SERVICE LETTER

No. 525

Subject: Addition of Lock Washers to Electrical Switch Installations

Models Affected: PA-23-250 (Six Place) Aztec, and PA-30 Twin Comanche

Typical Switch Installation

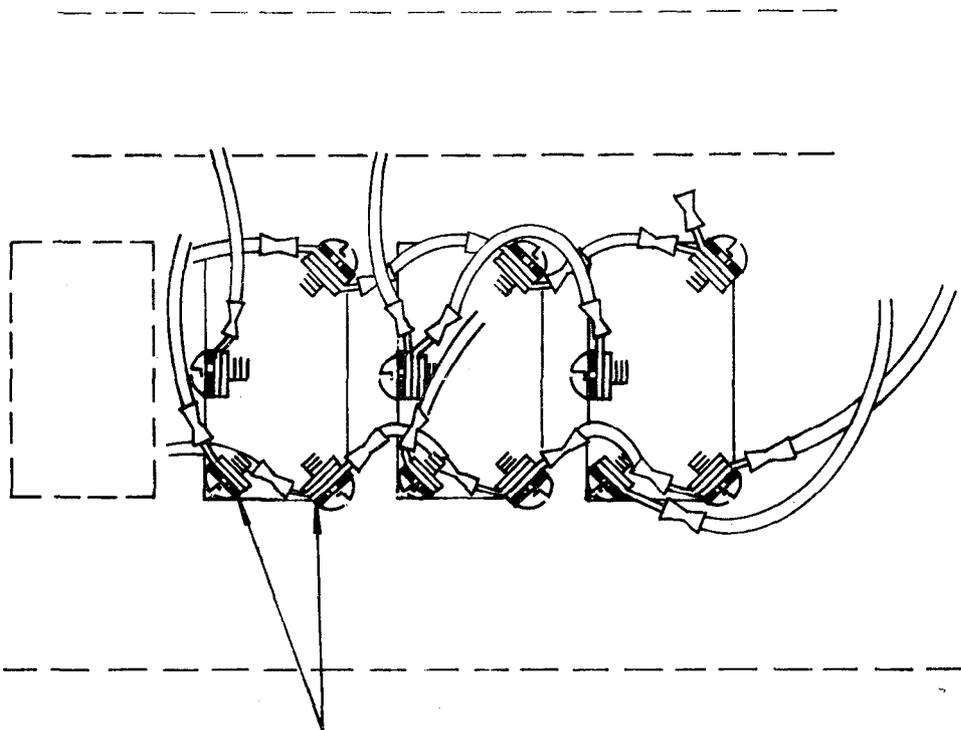
Lock Washer (AN936-A6) must be installed under screw head on each switch terminal.

Typical Circuit Breaker and Circuit Breaker Bus Bar Installation

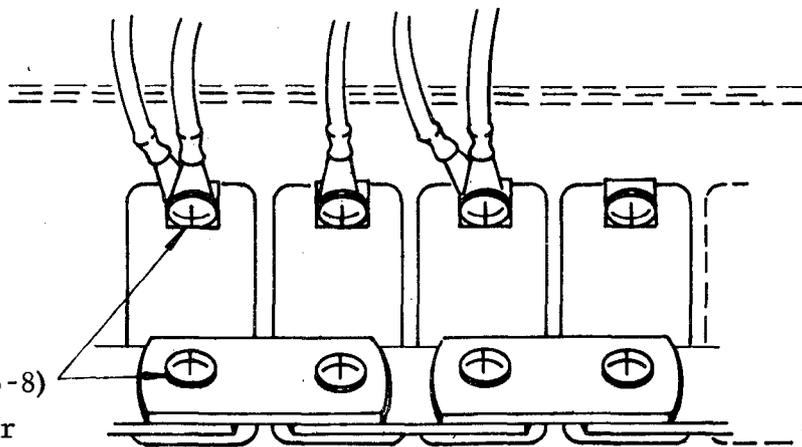
Lock Washer - (AN935-8) must be installed under screw head at each circuit breaker terminal.
